# **Final Safety Evaluation Report for Combined Licenses for William States Lee III Nuclear Station Units 1 and 2**

U. S. Nuclear Regulatory Commission  
Office of New Reactors  
Washington, DC 20555-0001

August 2016

## ABSTRACT

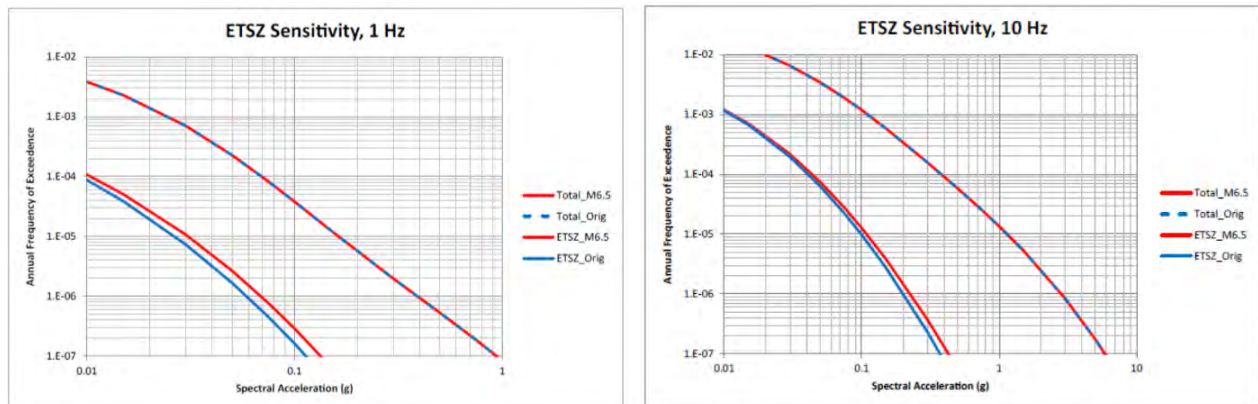
To evaluate the sensitivity of the maximum magnitude distribution of ETSZ seismic sources, the applicant first assumed that the ETSZ had a maximum magnitude distribution equal to that of the PEZ-N seismic source, the host source for the WLS site. The applicant then assumed that a **M6.5** earthquake occurred during the historical period within the ETSZ and re-assessed its maximum magnitude distribution, as shown in Table 2.5.2-2 of this report. The applicant then applied these updated, or sensitivity, maximum magnitude values to its ETSZ source and

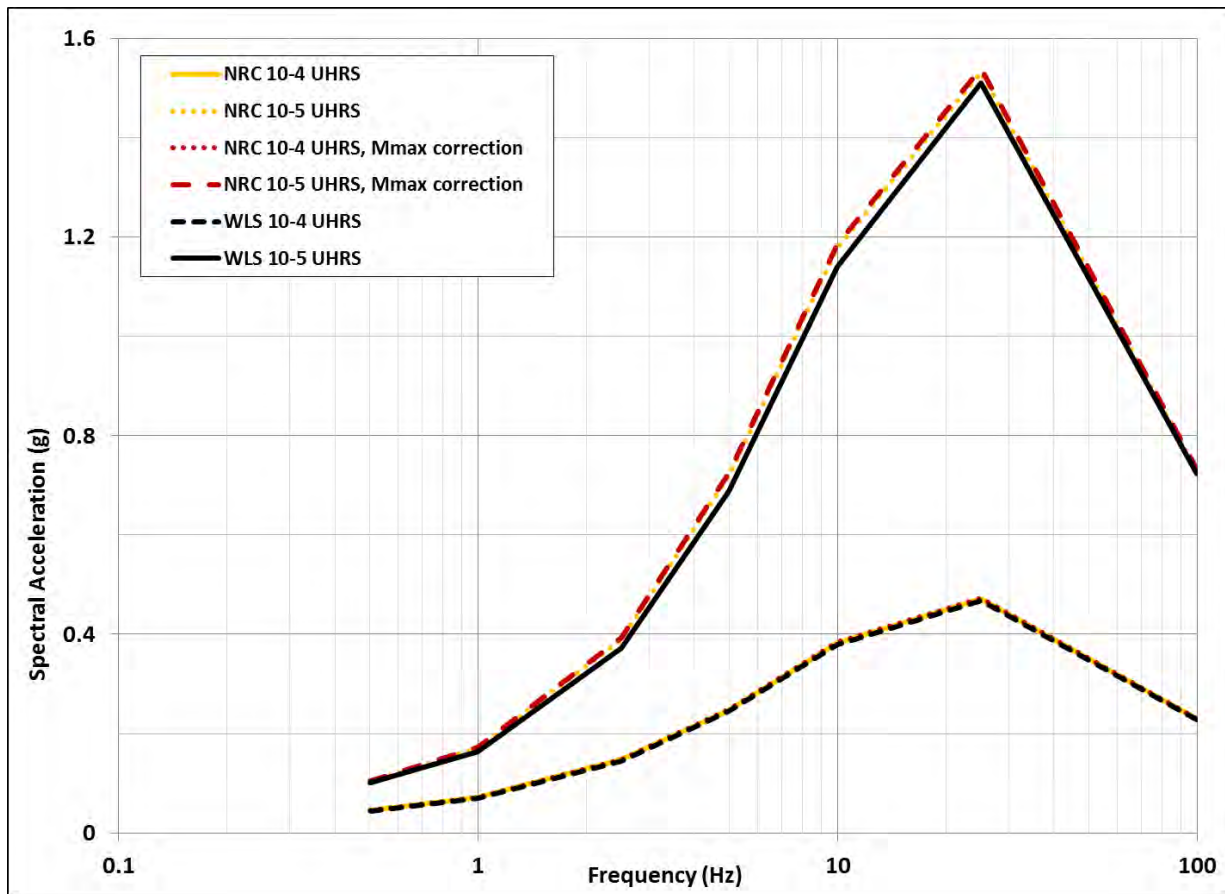
As part of its confirmatory analysis, the staff used the NUREG-2115 CEUS-SSC model Mmax, seismotectonic, and RLME sources and independently calculated the seismic hazard curves at the WLS site for all seven ground motion frequencies defined in the EPRI (2013) ground motion prediction models. From the NUREG-2115 seismic source model, the staff included all Mmax and seismotectonic sources zones defined by the NUREG-2115 model in its hazard calculation for the WLS site and truncated the zones' hazard contributions at a distance from the site of 500 km (310 mi). The staff also included all RLME source zones from NUREG-2115 and truncated the RLMEs' hazard contributions at a distance from the WLS site of 1000 km (621 mi). Figure 2.5.2-7 of this report shows the staff's results as compared to the applicant's for the generic hard rock UHRS at the annual frequency of exceedances of  $10^{-4}$  and  $10^{-5}$ .

**Figure 3.7.1.4-2 The WLS horizontal NI FIRS and the staff's (NRC) horizontal NI FIRS**

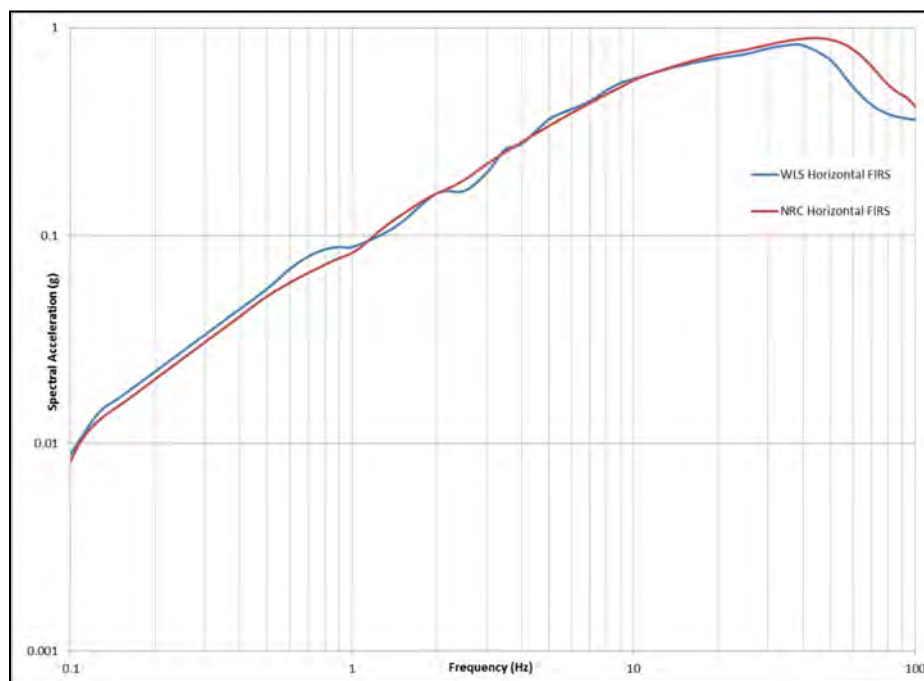
The staff noted a difference between the applicant's and the staff's NI FIRS results at high frequencies (between approximately 40 and 100 Hz). The staff noted the WLS FIRS amplification transfer functions show amplification from approximately 30 to 100 Hz due to the varying fill concrete beneath the WLS proposed structures, which means that at those frequencies the FIRS should have larger spectral accelerations than the WLS site-specific GMRS. In contrast, the WLS NI FIRS is less than the WLS GMRS at high frequencies. To investigate this issue, in RAI 118, Question 03.07.01-6, the staff requested that the applicant assess and evaluate the inconsistency of WLS FIRS amplification transfer functions, FIRS, and the GMRS and to provide a thorough description of the assessment and evaluation. The staff also requested that the applicant explain the basis and justify the conclusions regarding the relationship between the WLS site-specific amplification functions, FIRS, and GMRS.

In a July 24, 2014, response to RAI 118, Question 03.07.01-6, the applicant described that the noted differences in the relationships of the horizontal GMRS and FIRS are attributed to differences in high-frequency interpolation methods used to develop the rock (GMRS) and concrete (FIRS) spectral shapes. In Figure 3.7.1.4-3 of this report, the applicant presented the horizontal GMRS and FIRS A1 from WLS COL FSAR, Sections 2.5.2.6 and 2.5.2.7 (labeled as

**Figure 3.7.1.4-3 Comparison of the horizontal GMRS and FIRS A1 from the FSAR (“Orig”) and horizontal GMRS and FIRS A1 using the methodology consistent with that used to develop the FSAR NI FIRS (“Altern”). (Ref. RAI 03.07.01-6 response Figure 9)**

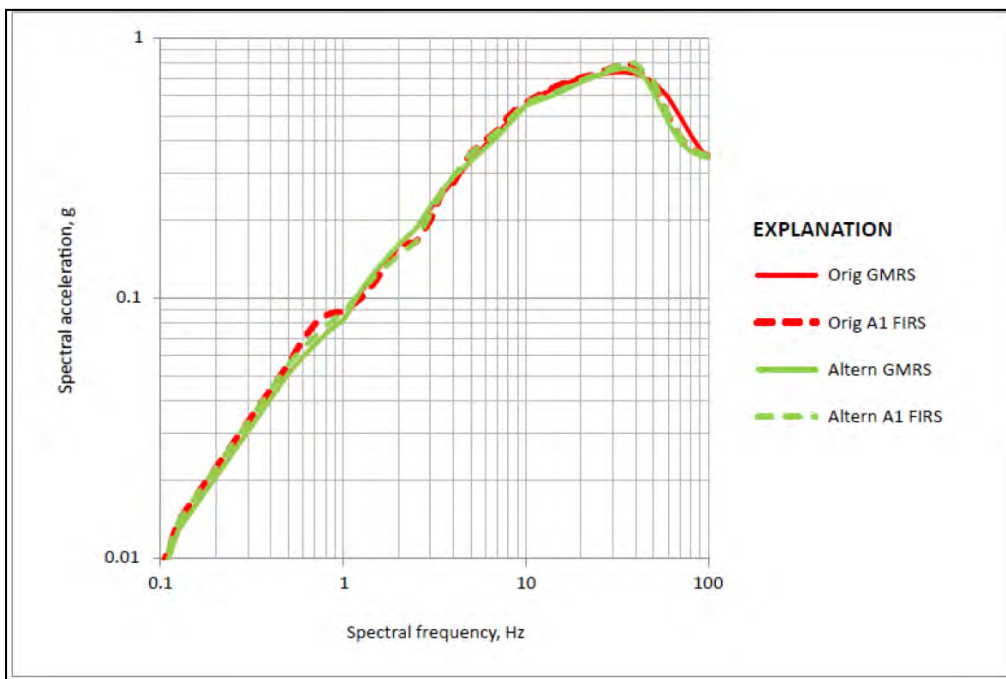
Based on this review, the staff concludes that the WLS COL FSAR Revision 9 horizontal GMRS and FIRS spectra are considered appropriate. Additionally, the staff also concludes that the difference in interpolation methods explains the differences between the WLS NI FIRS and the NRC NI FIRS shown in Figure 3.7.1.4-2 of this report. Accordingly, the staff concludes that the WLS NI FIRS satisfy the acceptance criteria of RG 1.208 and the requirements of 10 CFR 100.23, and considers RAI 118, Question 03.07.01-6 resolved. Based upon its review of WLS COL FSAR Section 2.5.2.7 and 3.7.1.1.1, the applicant’s response to RAI 118, Question 03.07.01-6, and the staff’s confirmatory analysis, the staff concludes that the applicant’s methodology and results for calculations of the site-specific NI FIRS are acceptable and resolved.
